CITY OF LA VISTA
MAYOR AND CITY COUNCIL REPORT
JUNE 19, 2007 AGENDA

Subject:	Type:	Submitted By:
APPLICATIONS FOR REPLAT, CONDITIONAL USE PERMIT (HOTEL), FINAL PUD PLAN & AMENDMENT TO PUD ORDINANCE — SOUTHPORT WEST REPLAT THREE	◆RESOLUTION(S) ◆ORDINANCE RECEIVE/FILE	ANN BIRCH COMMUNITY DEVELOPMENT DIRECTOR

RE: Proposed Conditional Use Permit
Lot 1, Southport West Replat Three
Proposed Courtyard Hotel
TD² File No. 171-345.2

RE: Proposed PUD Plan Amendment
Lots 1-3, Southport West Replat Three
Proposed Hotels & Conference Center
TD² File No. 171-345.3

EXHIBIT "C-1"

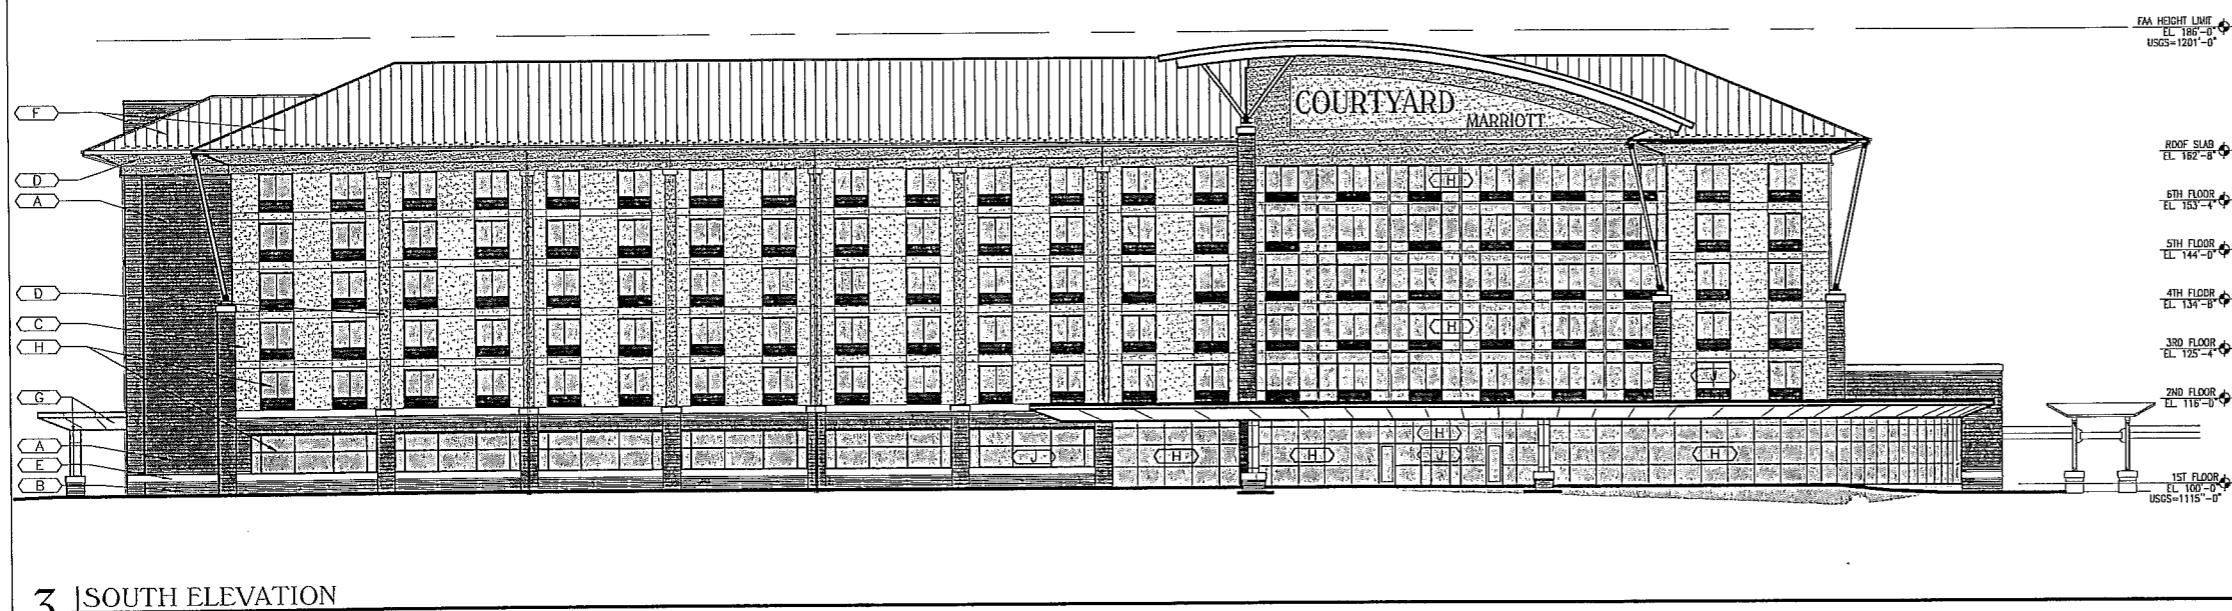
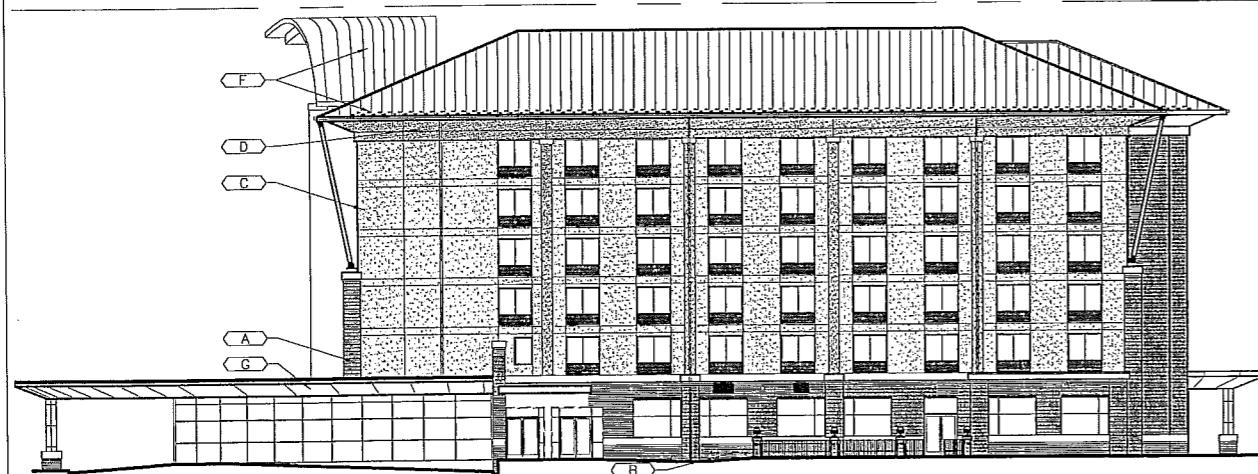
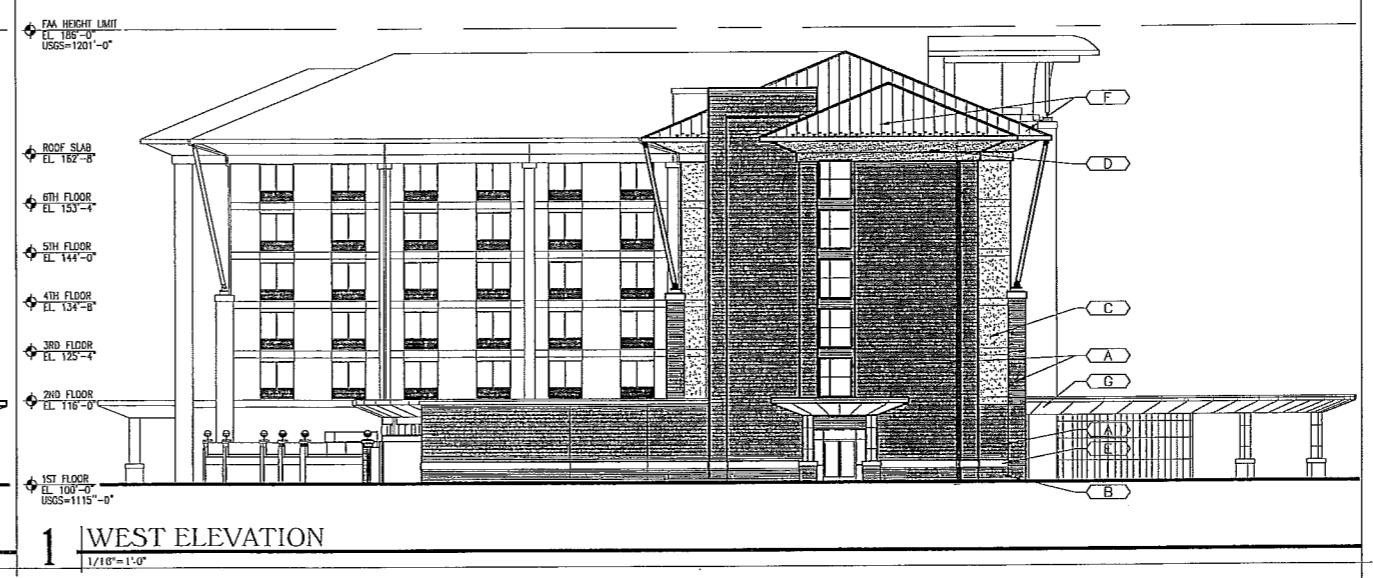
- The glass curtain wall above the entrance canopy needs to be revised to add interest and detail; this portion of the building does not have “an eclectic style that is weighted towards the historical” as required. Options would include sun shades, a different proportion of punched windows, more brick, etc.

- i. The elevation plans (Exhibits “C-1 and C-2”) and material samples submitted indicate a combination of brick, E.I.F.S., precast concrete and metal panels. The building has a recognizable base, mid-façade and cornice; **however the area of the glass curtain wall over the entry lacks interest and detail. Revisions are necessary to meet the general style requirements of the design guidelines which state the “development should have an eclectic style that is weighted towards the historical”.**
